Delmore Fast-Track

04/05/2026 – Auckland Council Response

Specialist Response Template – Fast-track Approvals Act 2024
Substantive Application – Parks Planning Response to applicant updates

1.0 Technical Specialist Memo – Parks Planning

Figure 1: Existing provision within wider catchment.

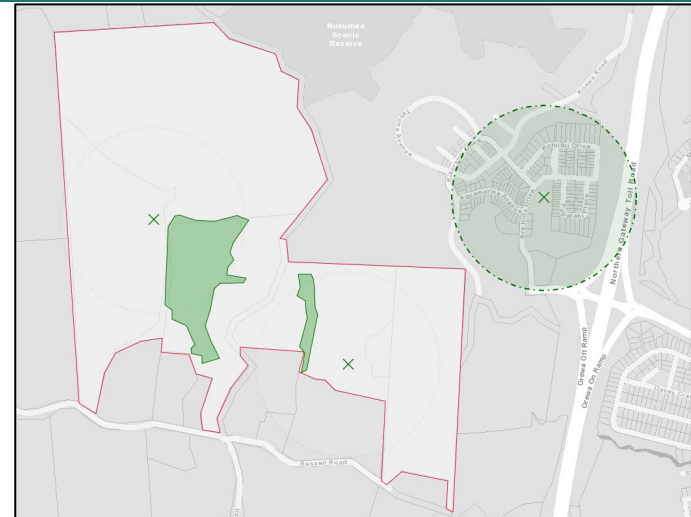
Information Request from Council on the lodged material	Applicant Response	Council Specialist Response
1. Open Space outcome for Lot 1800 is not protected The residential society mechanism applied to Lot 5020 has not been extended to Lot 5020. Unclear long-term ownership, management, and public access arrangements.	The applicant is willing to provide a neighbourhood park within Stage 1 where Council confirms its intention to acquire and vest the land, noting the proposed park meets the relevant size, accessibility, and design requirements. It is also our understanding that reserve acquisition is funded through development contributions, and therefore there is an appropriate mechanism available to enable Council to secure this land. However, if Council does not wish to acquire the land, it is appropriate that the area be developed for residential purposes. This is justified on the basis that the adjoining Ara Hills development is required to deliver a neighbourhood park which would adequately service future residents of the Delmore site. In contrast, the retention of a neighbourhood park within Stage 2 is supported, as this location is more removed from adjoining neighbourhood parks and is necessary to ensure an appropriate distribution of parks across the wider catchment.	Outstanding – The applicant has considered the residential society outcome for 5020 but not considered this for Lot 1800. Park provision is therefore not protected. It is positive that the applicant intends to retain a degree of open space provision regardless of whether acquisition proceeds. The proposal to maintain the Stage 2 park in perpetuity through a residents' society acknowledges existing gaps within the open space network in this greenfield context. Figure 1 presents a gap analysis which indicates that the level of service for both Stage 1 and Stage 2 parks is largely contained within the scope of the fast-track development. The Stage 1 catchment, modelled under a medium to high-density scenario, does not extend sufficiently to service other parts of the Ara Hills development (Figure 2). On this basis, the rationale used to secure the Stage 2 park through a residents' society due to a perceived network gap could equally be applied to the Stage 1 park, supporting its retention in perpetuity.

Figure 2: Updated catchment of Delmore park locations.

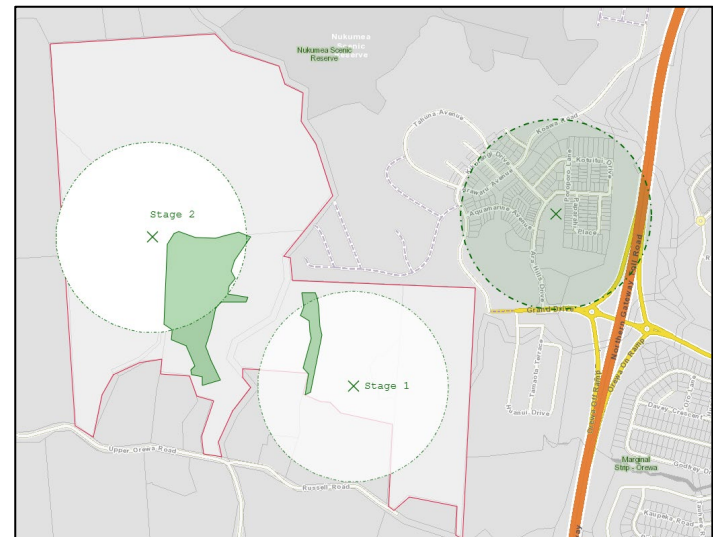
<u>Please note previous incorrect references to Lot 1800 and 5020. Lot reference within column 1 have been edited accordingly.</u>
2. Access pathways into park space (Lot 5020) Drawing 2535/36 (Stage 2 Lot Design Part 10) depicts walkway connections from the private lots into the adjacent park lot (5020). This is not supported from a Parks Planning lens.	These paths will be removed from the landscape plans. A full set of updated landscape plans will be provided on 20 April, however some preliminary updates are attached.	Resolved - Considered to be addressed in depictions from high level landscape plans provided on 20/04/2026. Detailed plans of staging of landscape plans have not been provided.
